**National Infrastructure Planning
Cleve Hill Solar Park
CPRE Kent (Reference 20022146)**

STATEMENT TO FROM OPEN FLOOR HEARING 10 September 2019 10 am.

Fig. 1. Plan to illustrate distribution of flood flows into Faversham Creek

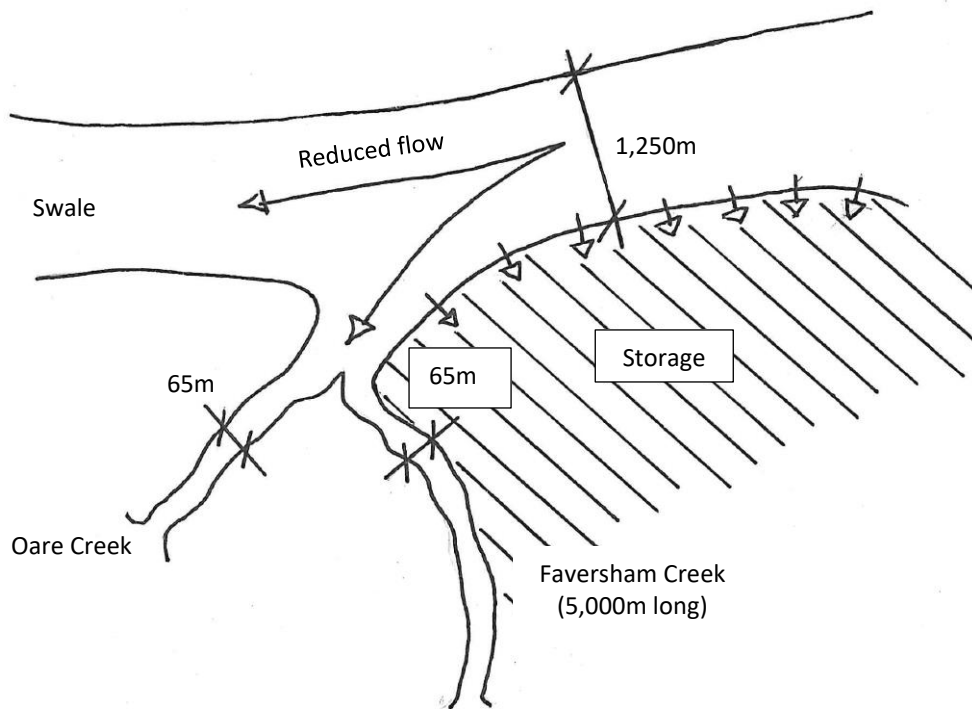
2. Distribution calculation to estimate where the reduction of flood surge occurs. (See Figure 1)

The distribution has been estimated as pro rata on the channel width. Total flow is 14.76 m³

Flow distribution pathway	Width of channel in metres	% of flow diverted into storage	Relief Volume.Mm ³
Swale	1,250	90	13.3
Oare Creek	65	5	0.69
Faversham Creek	65	5	0.69
Total	1,380	100	14.76

Equates to reduction of flow in Faversham Creek of 32 cumecs over 6 hours.

Fig. 2. Cross section of Faversham Creek

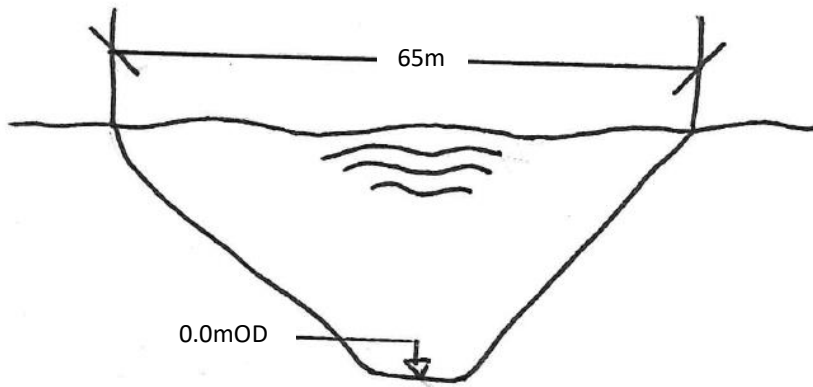
3. How this distribution of flow relief affects Faversham Creek. (See Figure 2)

Creek channel length 5,000m, so plan area of creek channel = 5, 000 x 65 = 325,000 m² land outside creek channel that is inundated.

Length 3.000m.

Assume flood plain ≈ average 150m wide in Faversham. (See Figure 3)
